# NOTICE OF DECISION

## DECISION OF THE HEARINGS OFFICER

**CONDITIONAL USE / CLASS 3 SITE PLAN REVIEW / CLASS 2 DRIVEWAY  
APPROACH PERMIT / CLASS 1 DESIGN REVIEW CASE NO.: CU-SPR-DAP-  
DR22-07**

CONDITIONAL USE / CLASS 3 SITE PLAN  
REVIEW / CLASS 2 DRIVEWAY APPROACH  
PERMIT / CLASS 1 DESIGN REVIEW FOR  
2410 FAIRGROUNDS ROAD NE - 97301

SPR 2

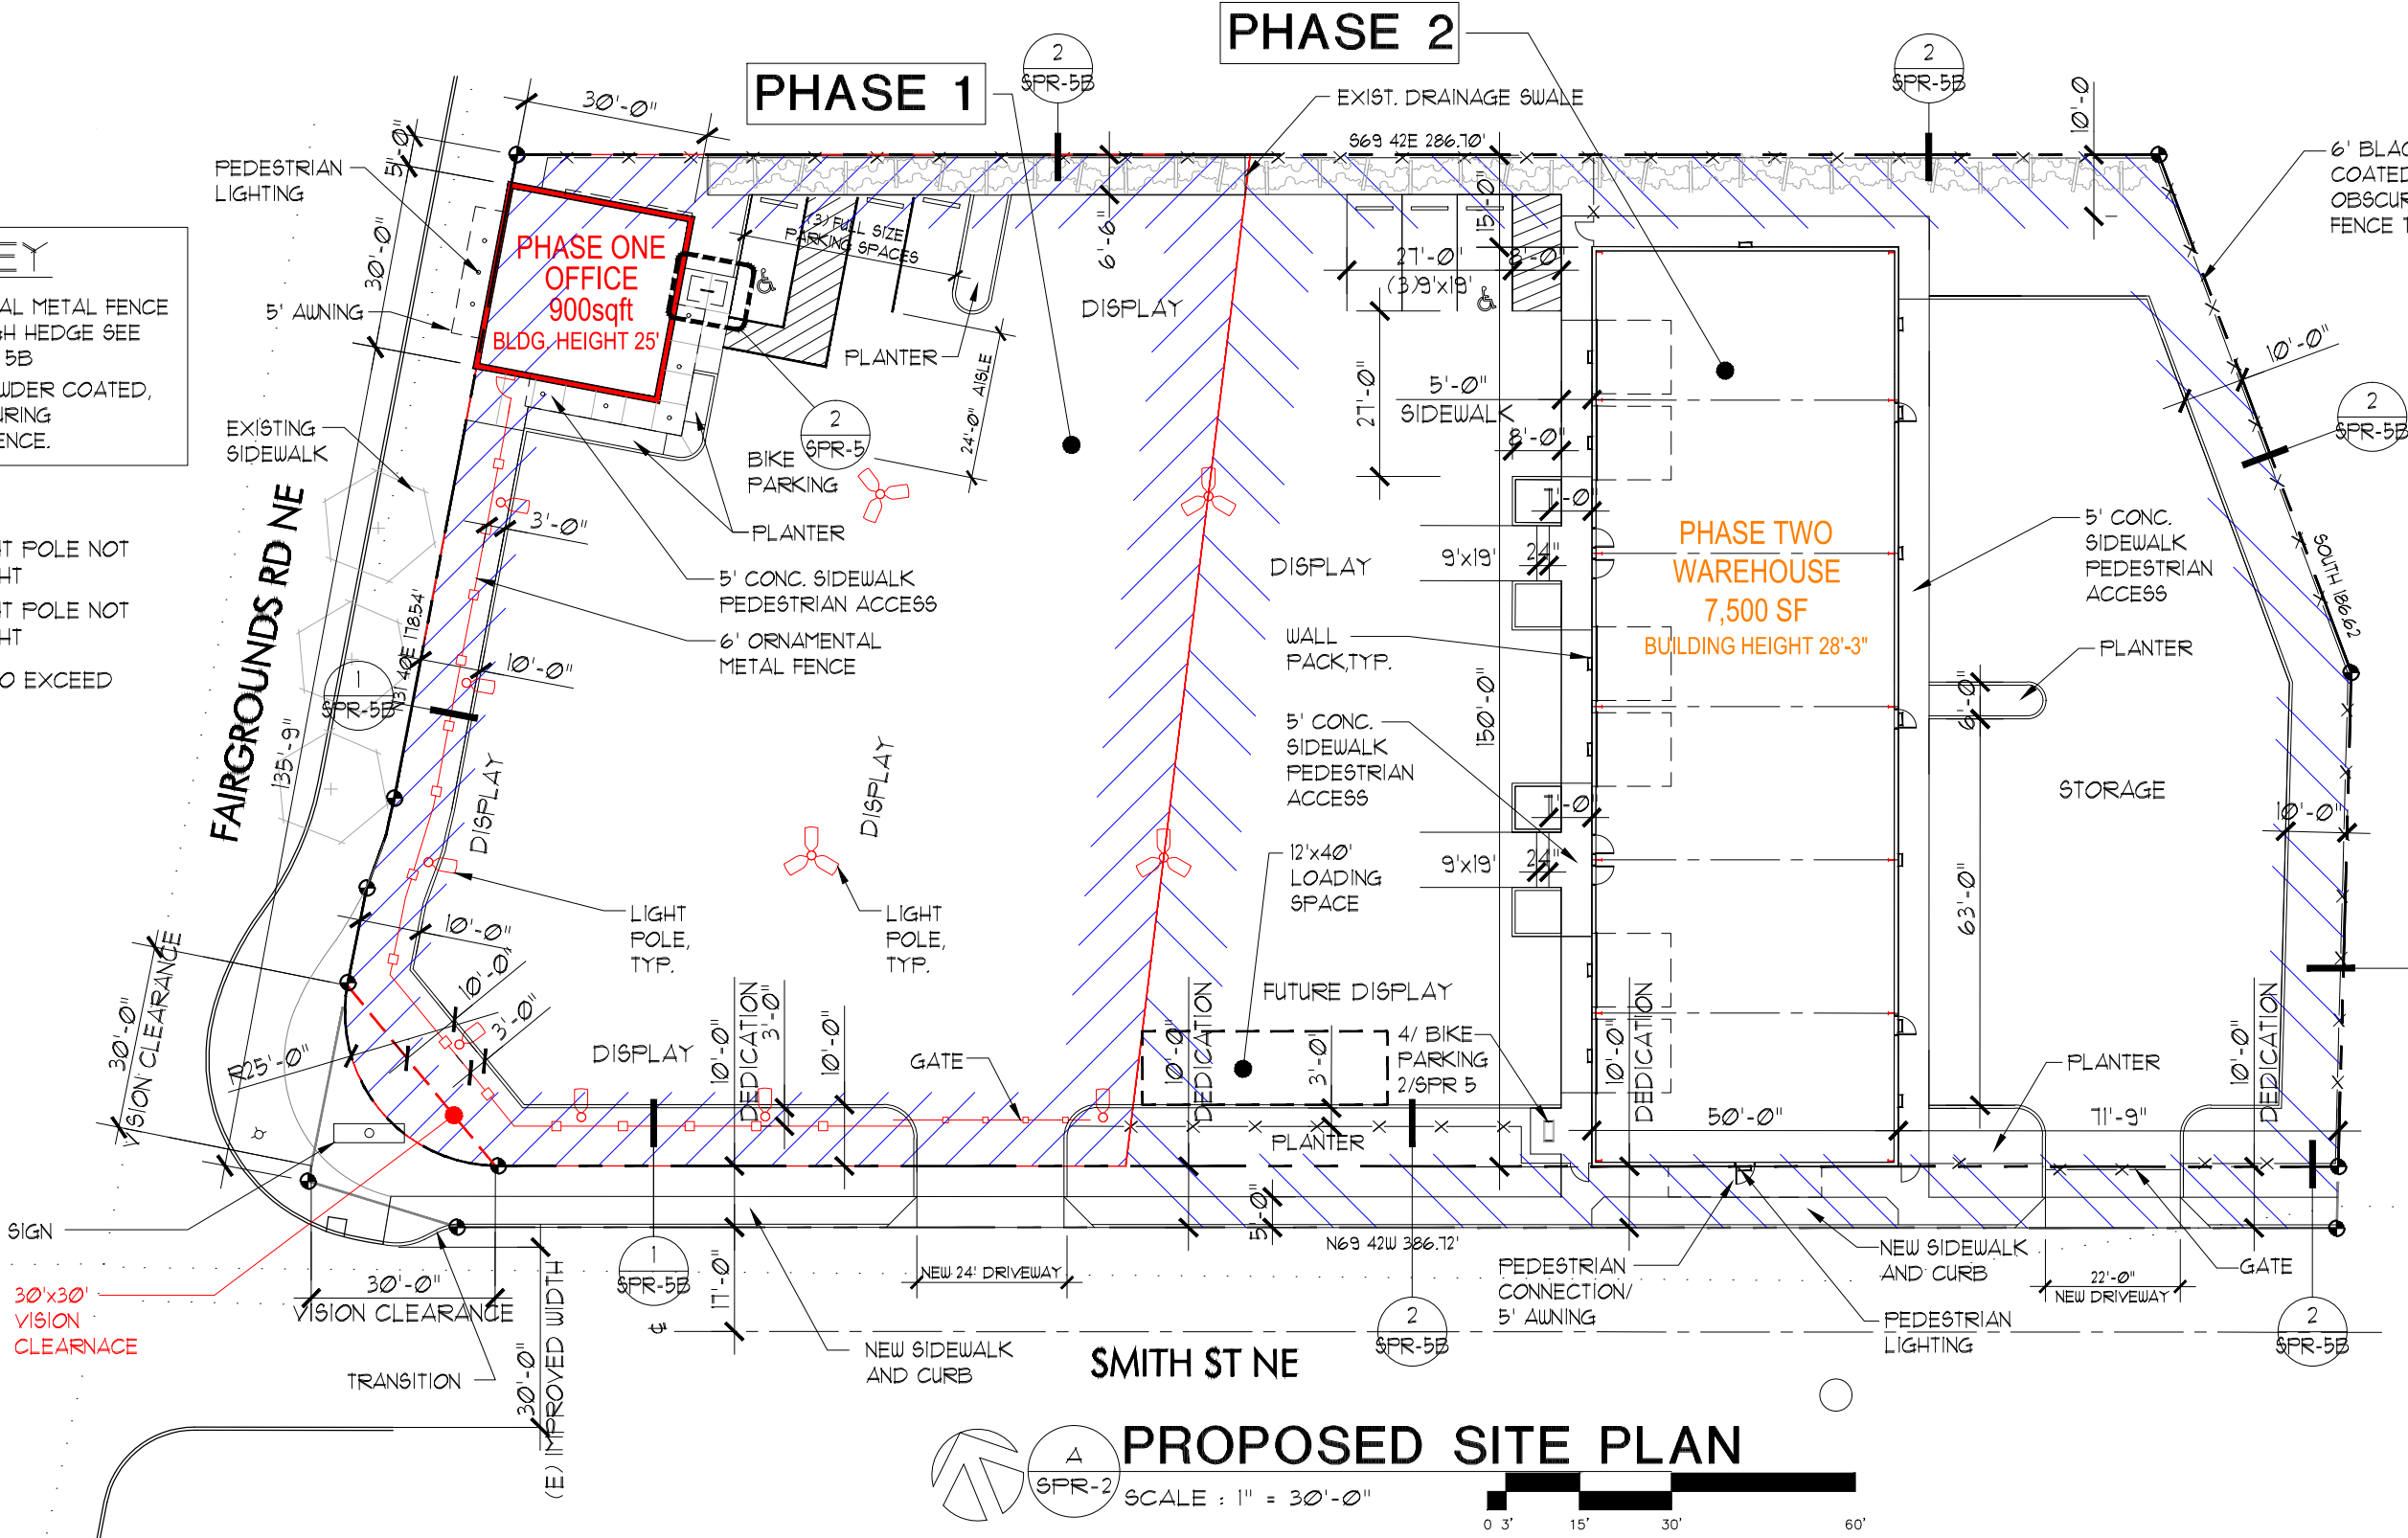
A combination of landscaping and non-sight-obscuring fencing will be provided along the frontage of Fairgrounds Road NE and Smith Street NE to mitigate the visual impacts while allowing the applicant to display vehicles. Along the north and east boundaries of the project area, new landscape plantings and fencing are proposed to minimize the visual impact and potential noise generated by the activities occurring on the site.

**Finding:** The proposed sales office building is setback approximately five feet, and the vehicle use area is setback approximately five feet from the northern boundary, in compliance with the minimum setback requirements.

**Finding:** The proposed vehicle use area is setback approximately 10 feet from the right-of-way for Smith Street NE, and is in compliance with this setback requirement.

**Finding:** The proposed vehicle use area is setback approximately 10 feet from the right-of-way for Fairgrounds Road NE, in compliance with this setback requirement.

**Finding:** The applicant's written statement and site plan indicates that the proposed vehicle display area will be screened from Fairgrounds Road NE and Smith Street NE using a six-foot-tall ornamental fence and a minimum three-foot wide landscape strip in compliance with this design standard.

**Finding:** The proposed site plan indicates that proposed vehicle use areas will be setback from Fairgrounds Road NE and Smith Street NE by a ten-foot-wide landscape strip, meeting the landscaping requirements in this section.

- Condition 2:** Prior to building permit approval for the first phase of development, the applicant shall demonstrate that a minimum of 15 percent of the development site will be landscaped. The applicant may request relief from this standard by submitting a future Class 2 Adjustment.

- Condition 3:** Cast iron or wrought iron fencing shall be installed along the Fairgrounds Road NE frontage.
- Condition 4:** The applicant shall demonstrate that all applicable off-street parking requirements of Chapter 806 are met at the time future use(s) are established for the Phase 2 building.

**WAREHOUSE BUILDING - EAST ELEVATION**  
A  
A32  
SCALE : 1/16" = 1'-0"

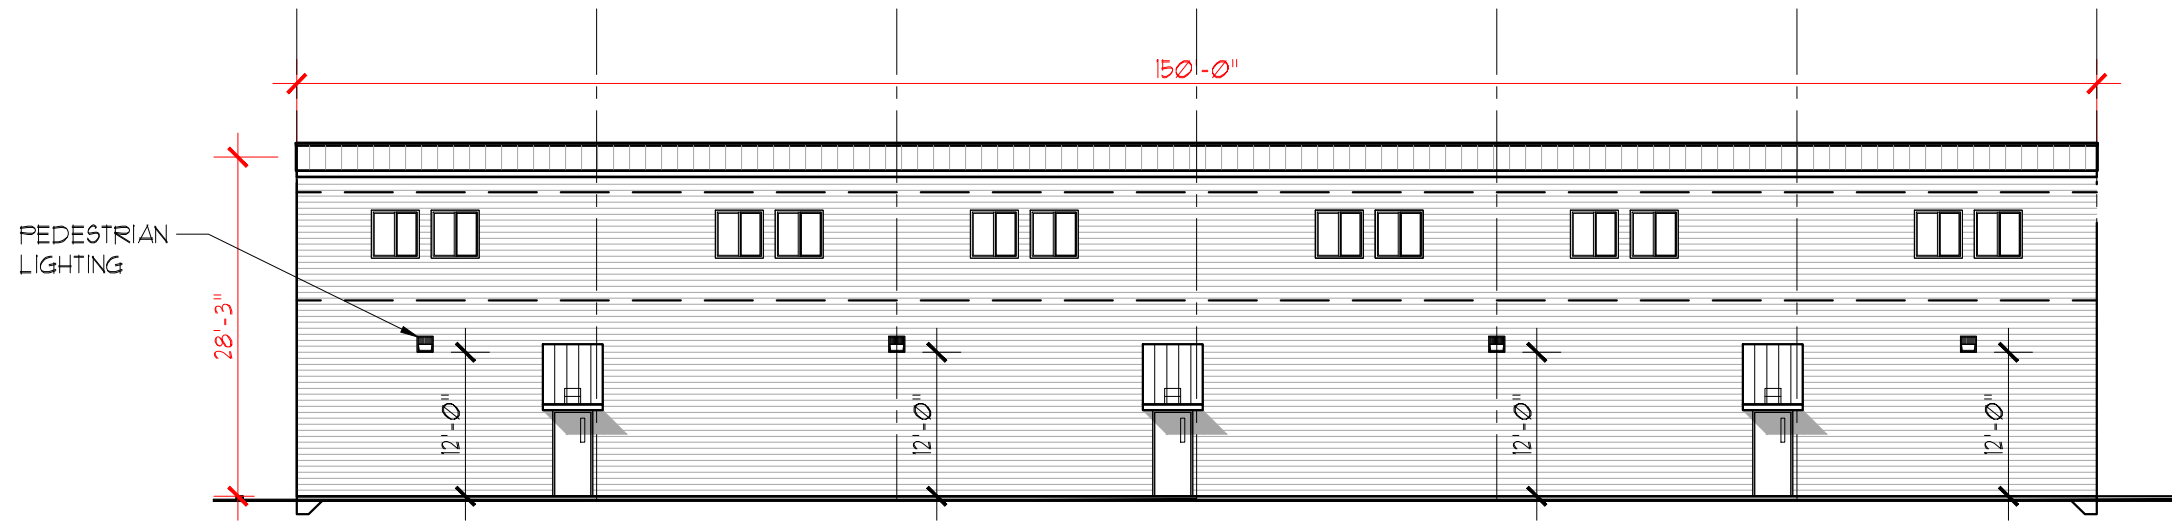
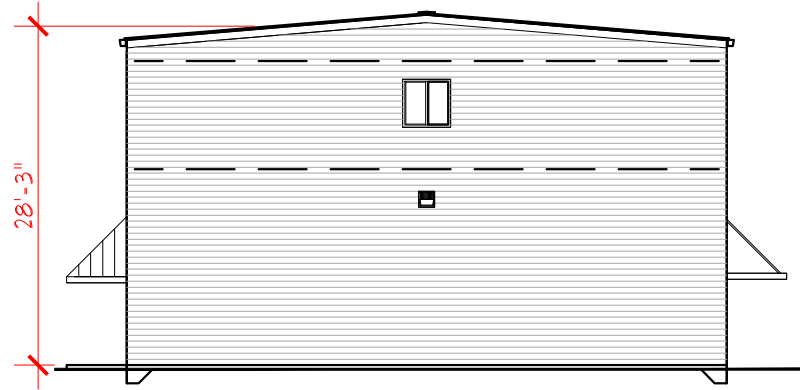
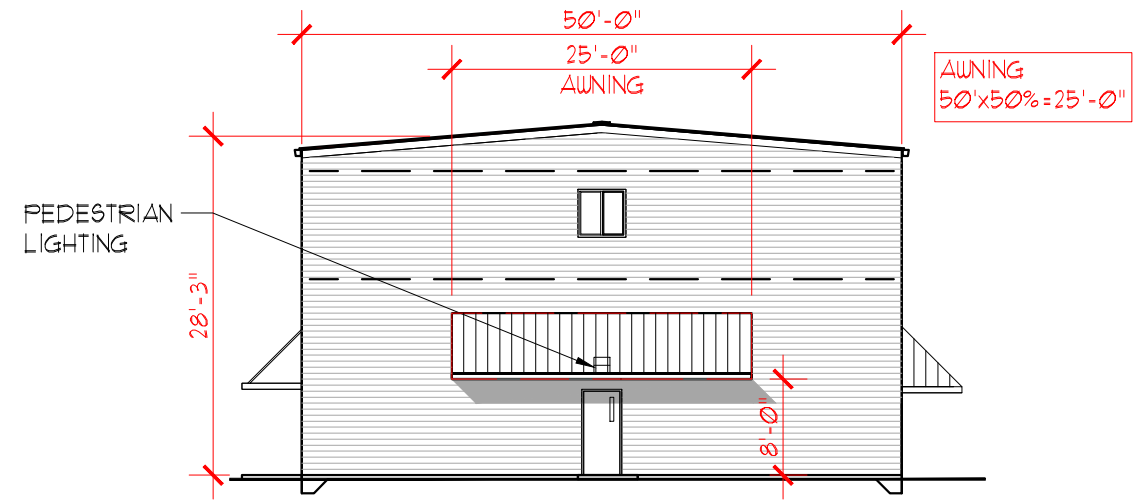
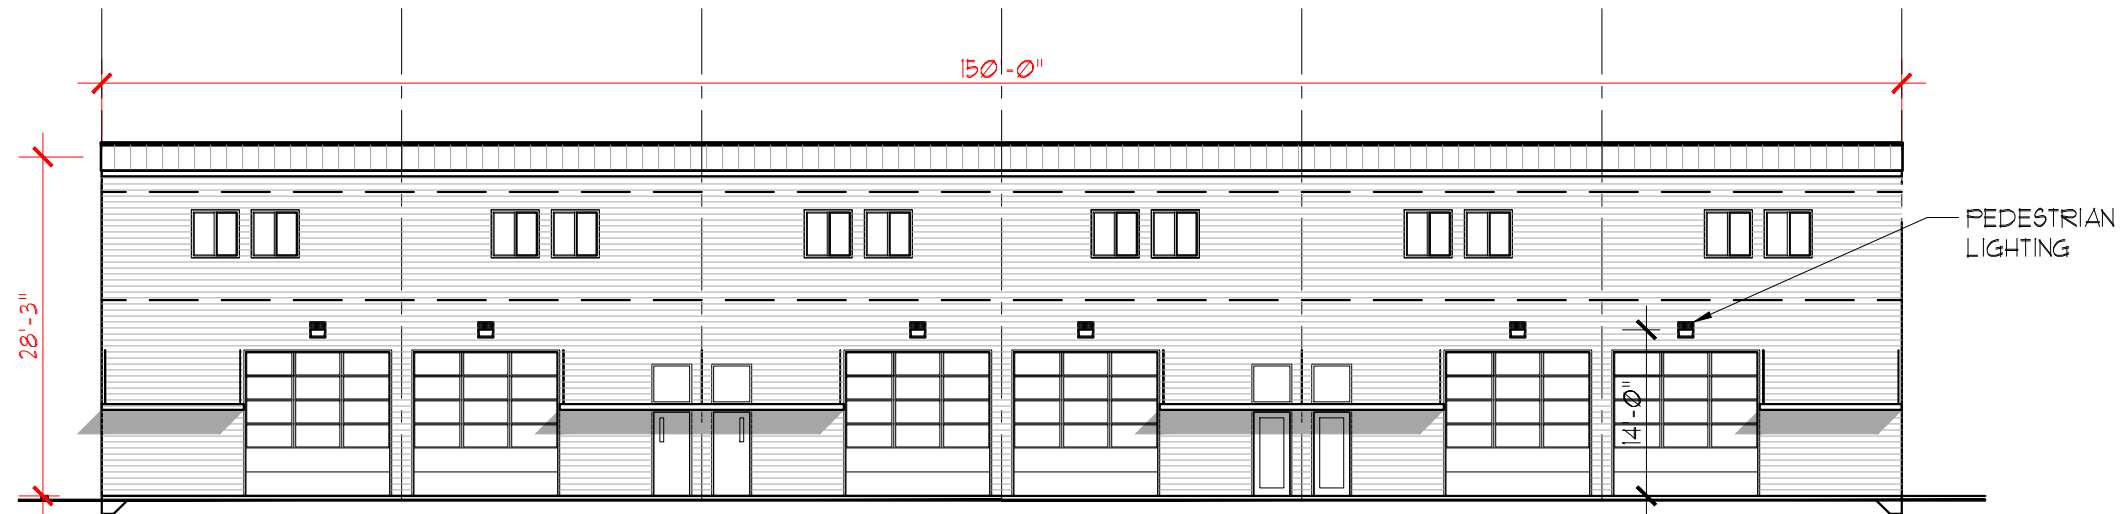
The building in Phase 2 has approximately 325 feet of sidewalks and pedestrian connections abutting the building façades. The elevation plan indicates that awnings or canopies will be provided above approximately 115 feet (35.4 percent) of the adjacent walkways, which does not comply with the minimum standard. Additional awnings or canopies will need to be provided above adjacent sidewalks and pedestrian connections.

- Condition 10:** Weather protection, in the form of awnings or canopies, shall be provided along a minimum of 50 percent of the length of the ground floor building façade adjacent to sidewalks or pedestrian connections for the proposed building in Phase 2.
